Subject: SR 429 (Wekiva Parkway)/SR 417 and Interstate 4 Value Engineering Study  
Recommendation Dispositions.

FPID: 240200-4-52-01

## SR 429 (Wekiva Parkway)/SR 417 and I-4 Interchange

### Value Engineering Study **Draft** Report

**RECOMMENDATION No. 20: Create a grade separated Diverging Diamond Interchange**

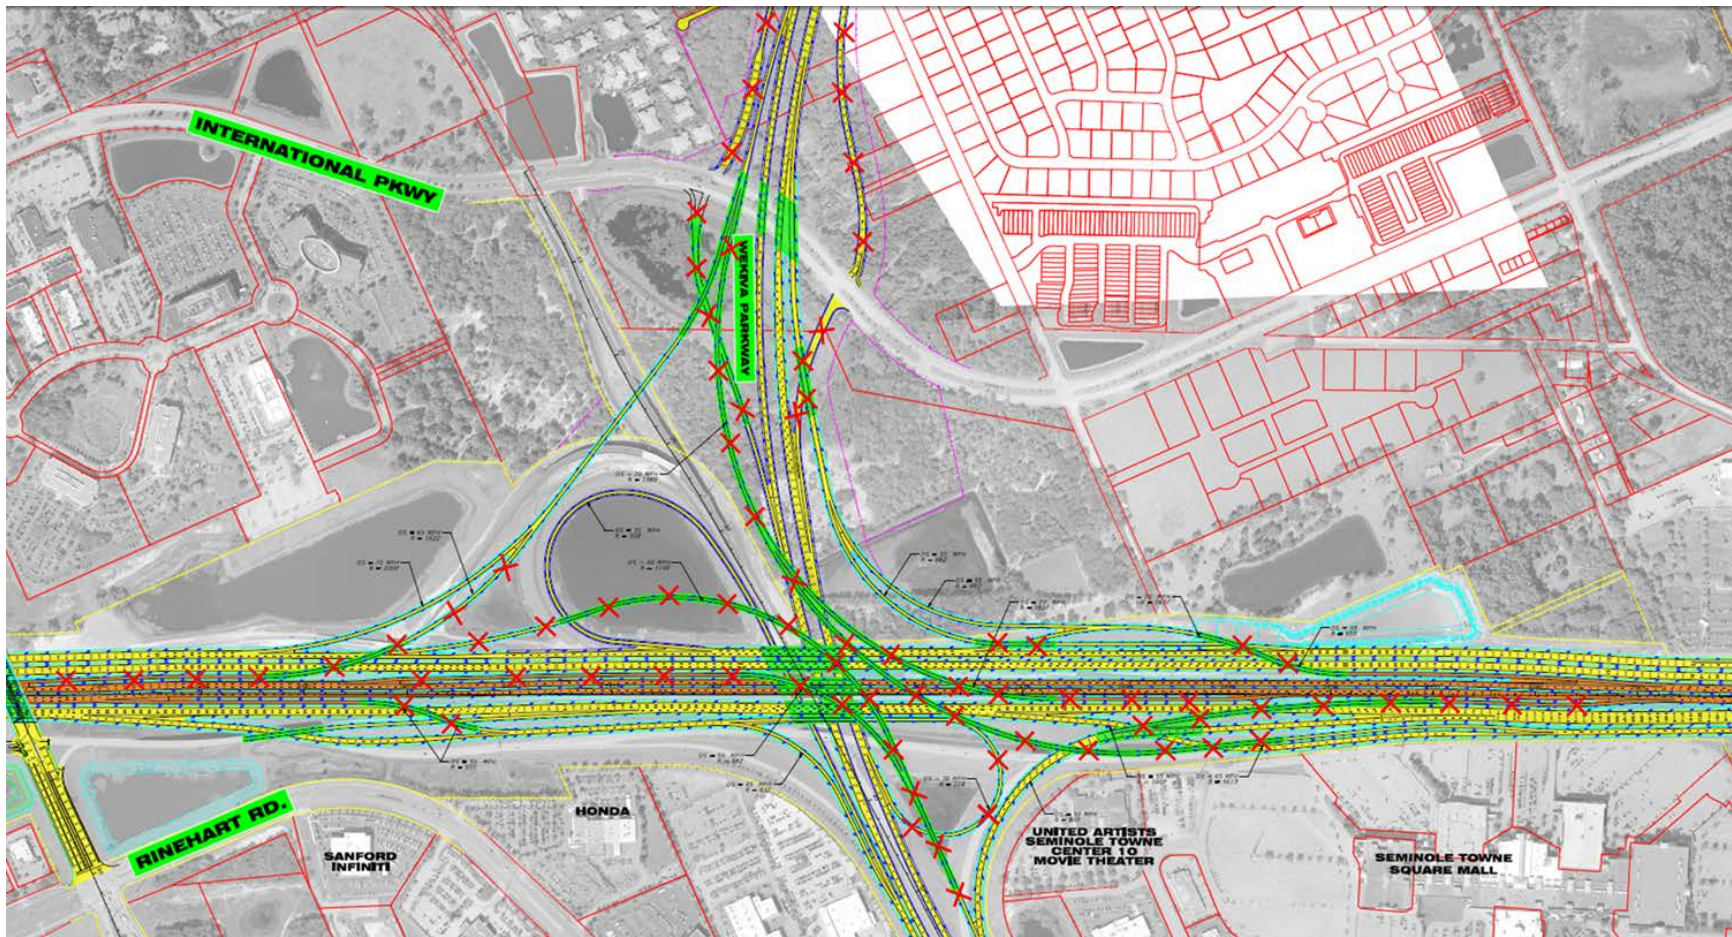
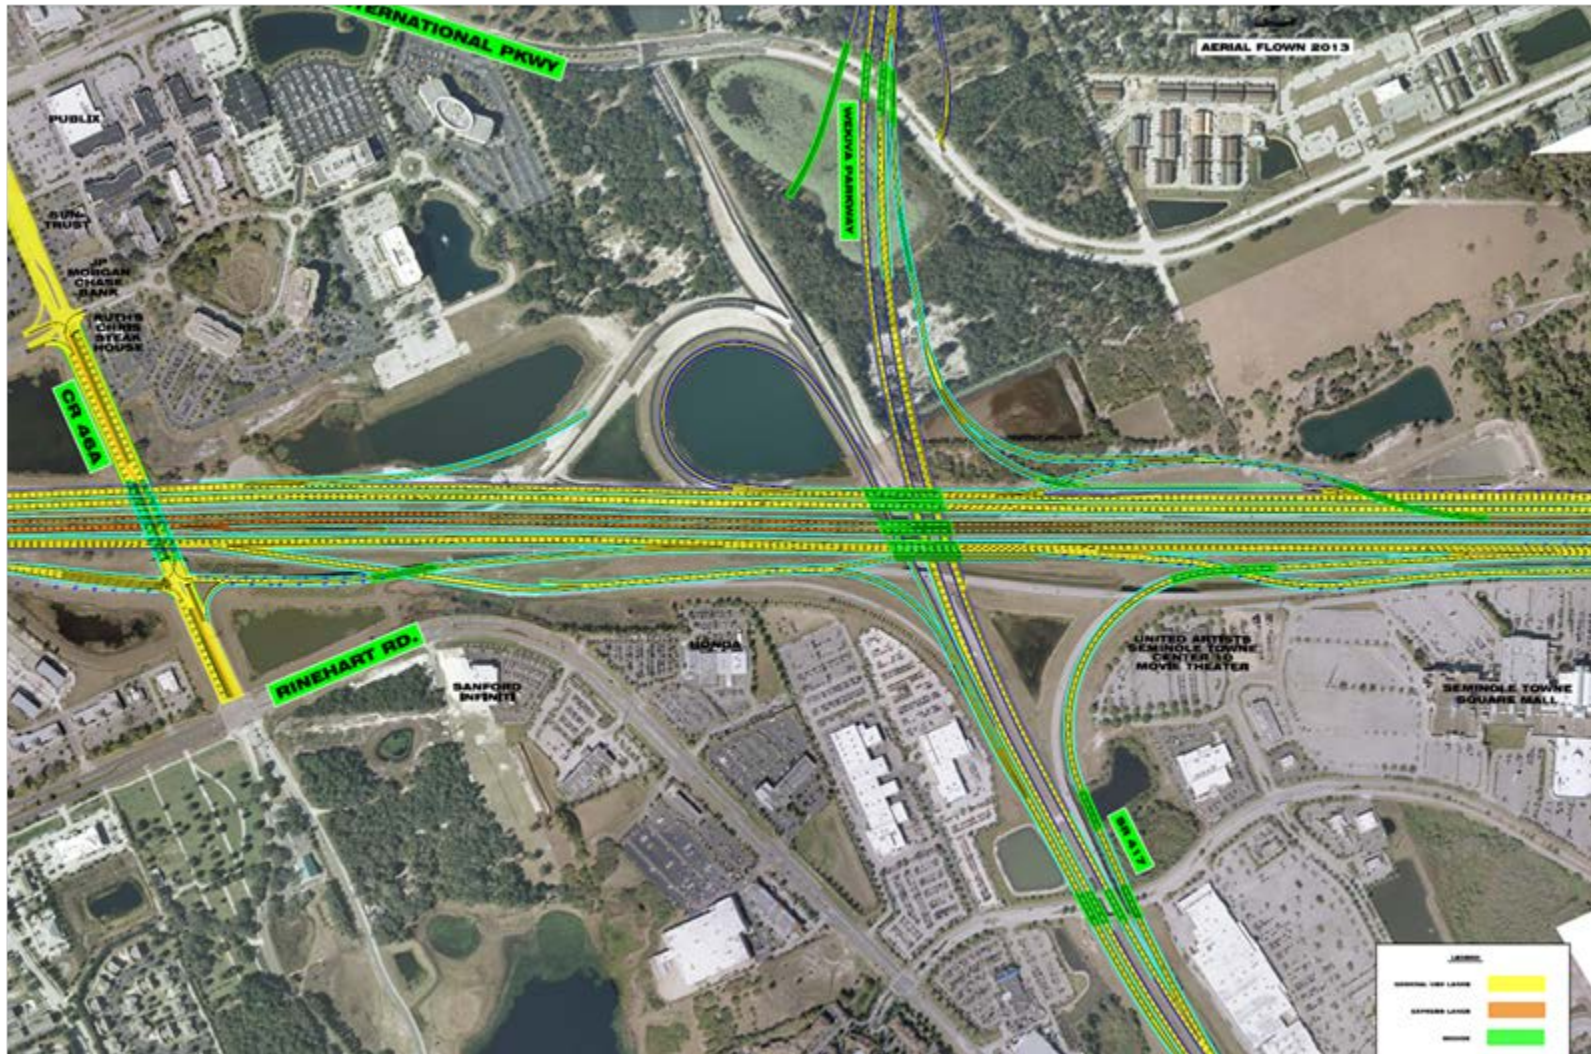
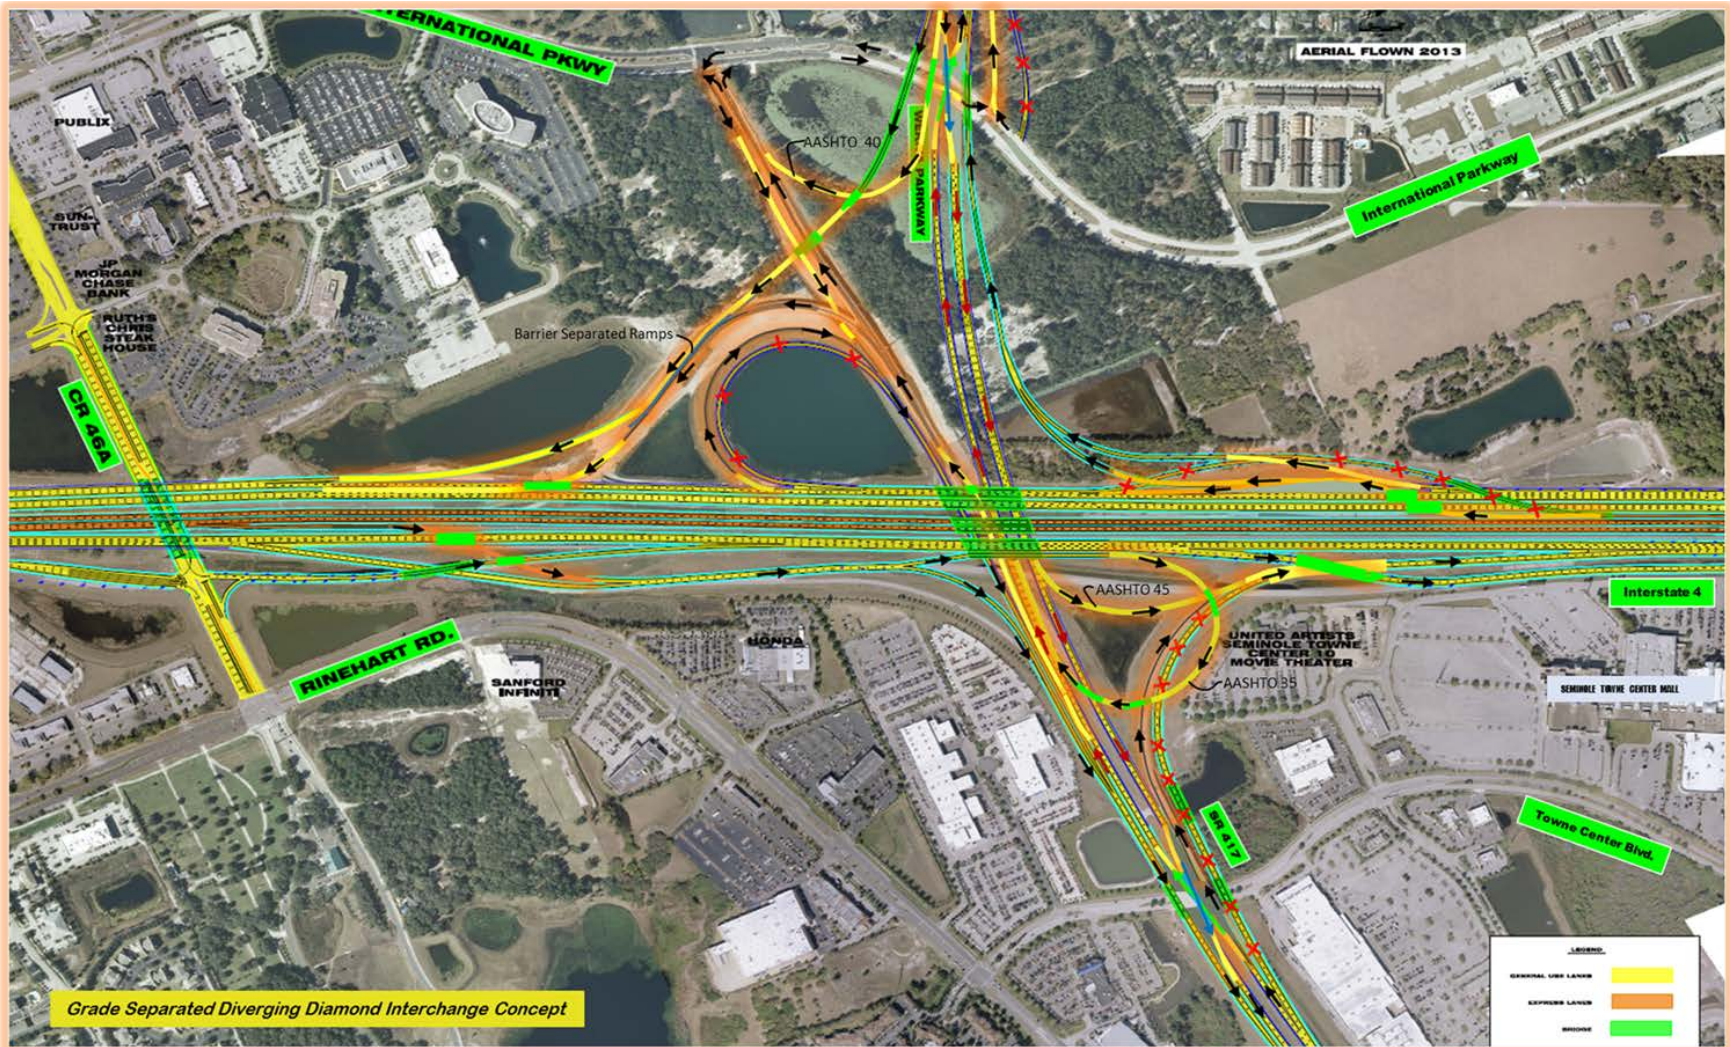
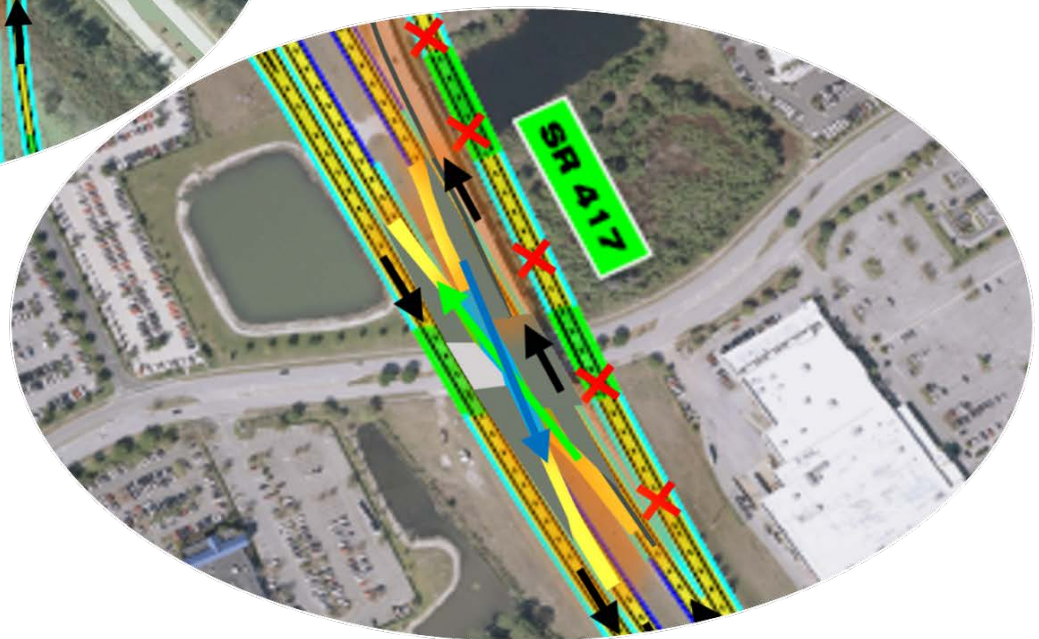
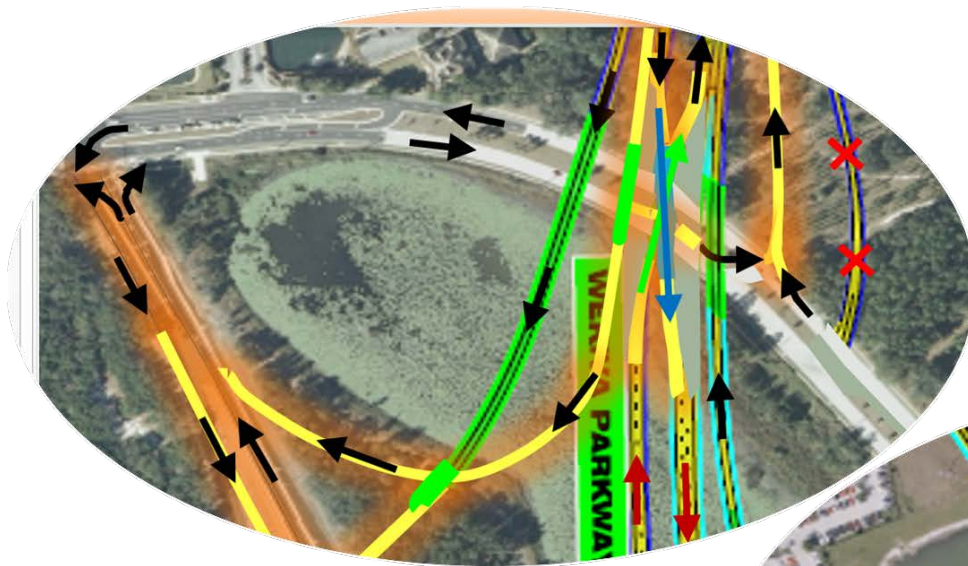
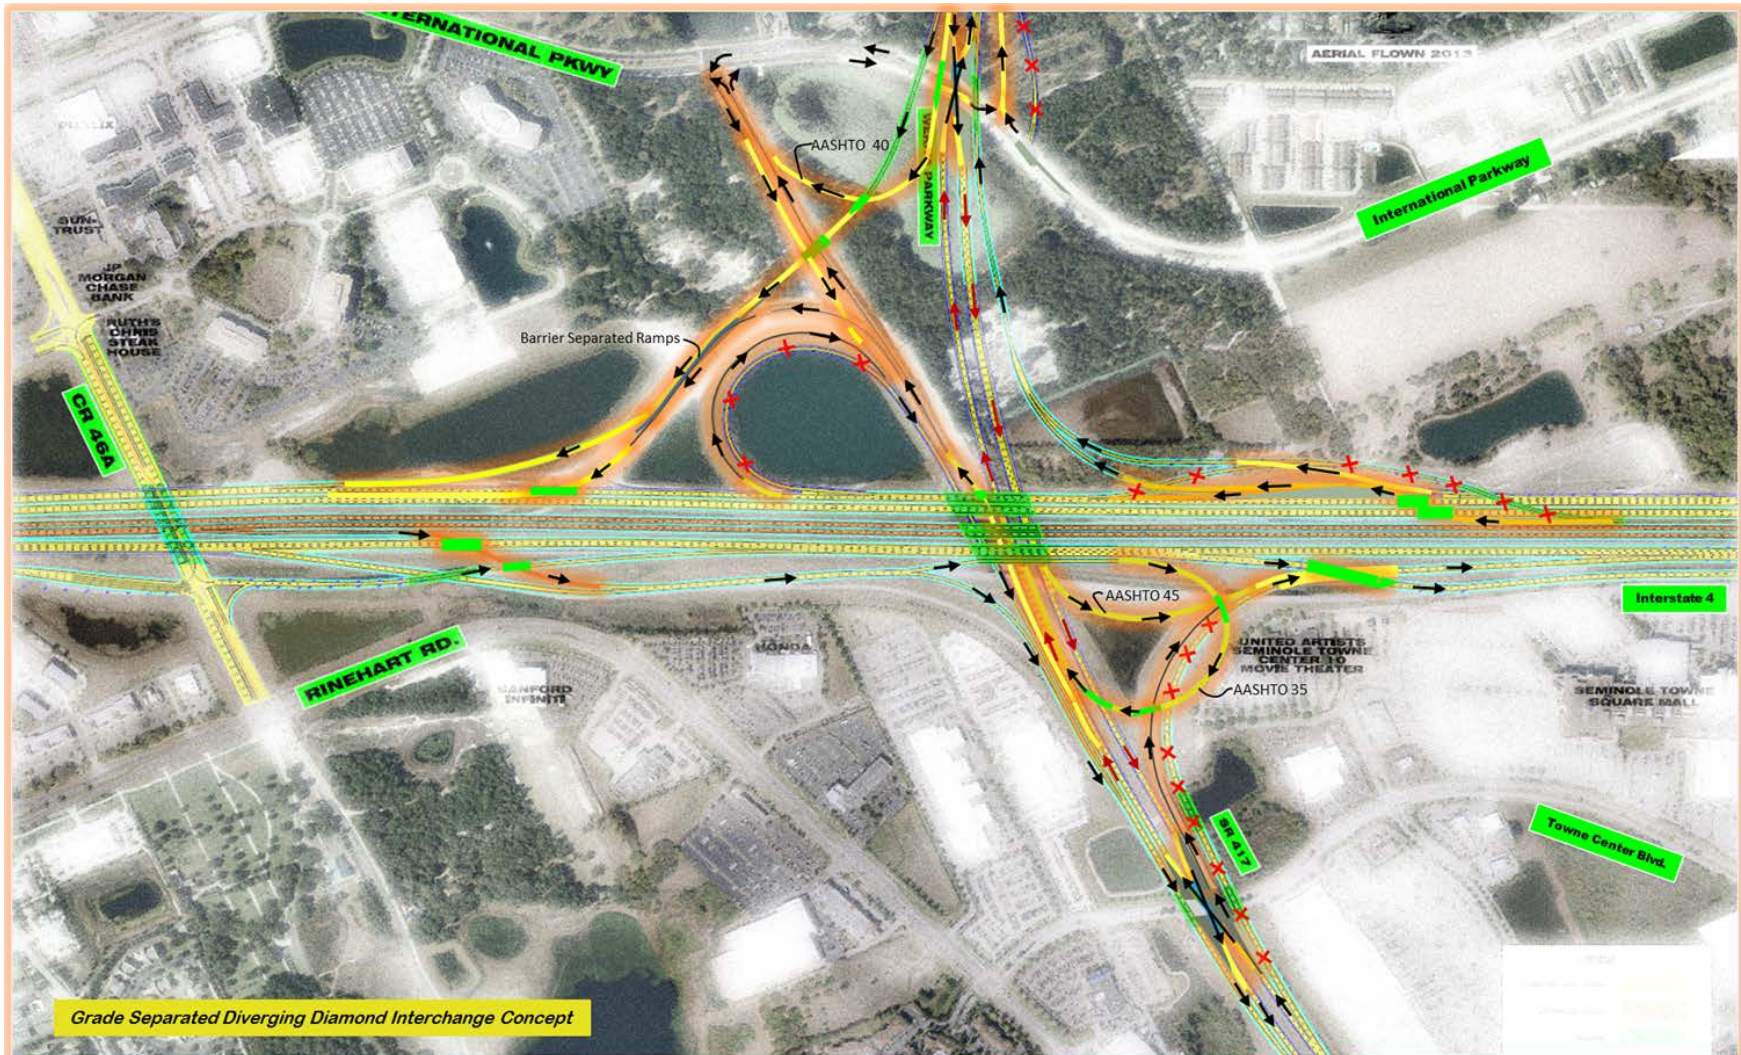
Recommendation 20: Construct a grade separated diverging diamond interchange (DDI) between Town Center Blvd. and International Parkway that allows salvaging the existing ramps and connections in southwest quadrant to I-4 and to and from International Parkway. Eliminates all flyovers and brings the proposed interchange down to a second level interchange except at the grade separated diverging points where a third level bridge would be needed. Corresponding changes and improvements to International Parkway interchange with ramp deletions and signal deletions. This VE alternative only adds one half-signal (for northbound to westbound lefts) to International Parkway corridor as opposed to two in the current proposed concept. Virtually no change in traffic flow for northbound direction on International Parkway compared to existing conditions.

Accepted. A DDI alternative was developed and will need to be evaluated as a viable option.

**RECOMMENDATION No. 21: Reconfigure the International Parkway and Wekiva Parkway interchange to a tight diamond interchange and move the bridged ramp connections to the outside.**

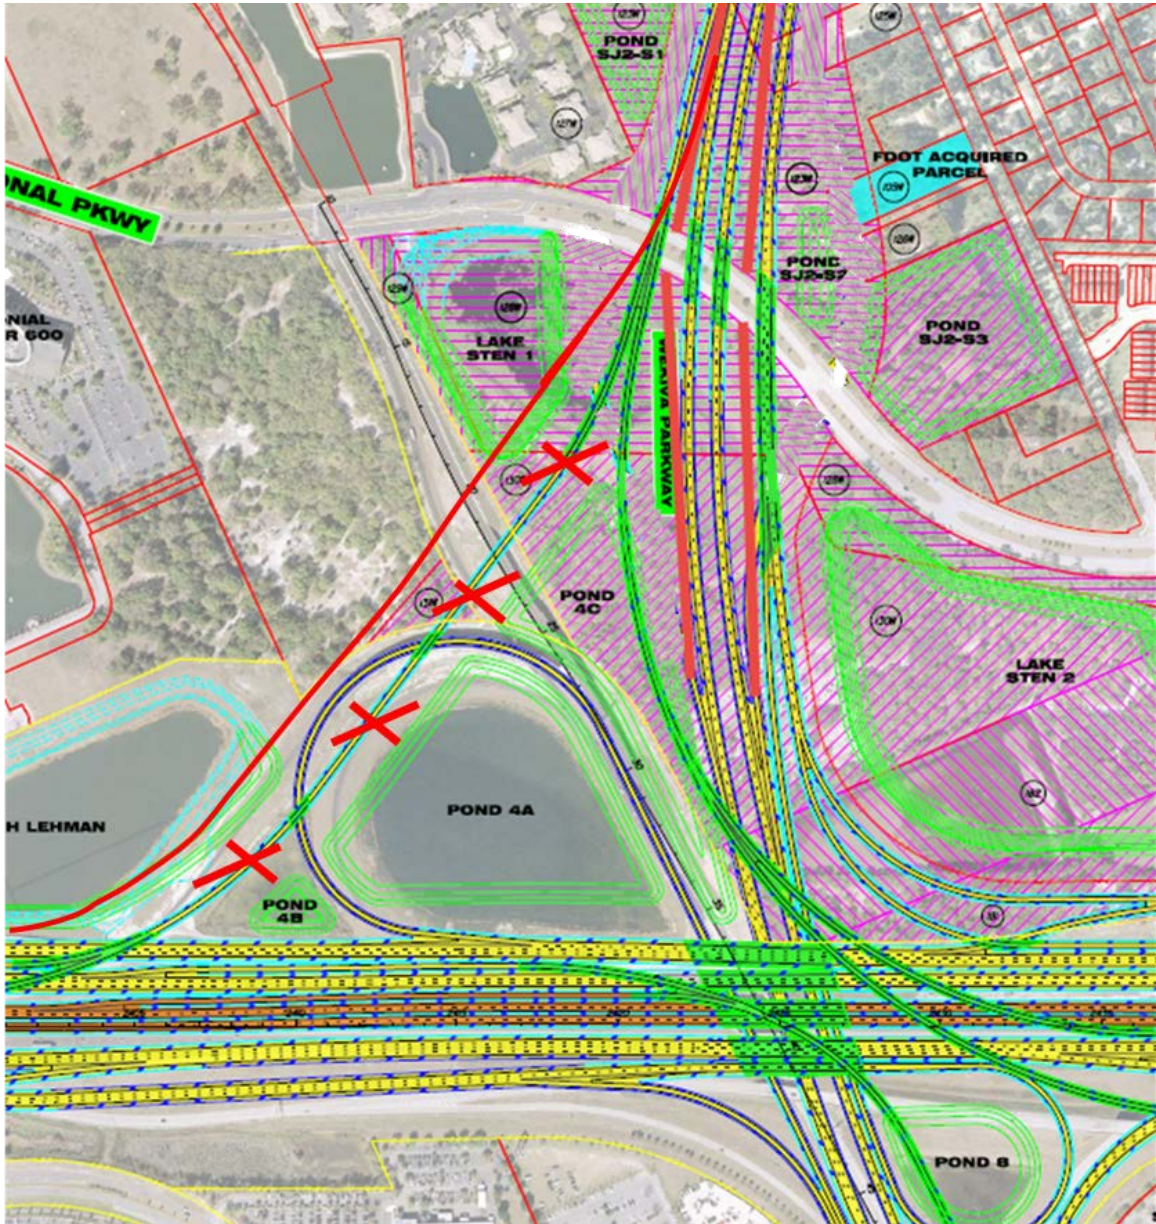
Recommendation 21: Reconfigure the interchange to a tight diamond urban interchange and move the bridged ramp connections to the outside.

Accepted. It appears that realigning this interchange to a tight diamond is a viable option and will be incorporated into the alternatives. If the interchange configuration is changed to a DDI then this option is not applicable. (Atkins)
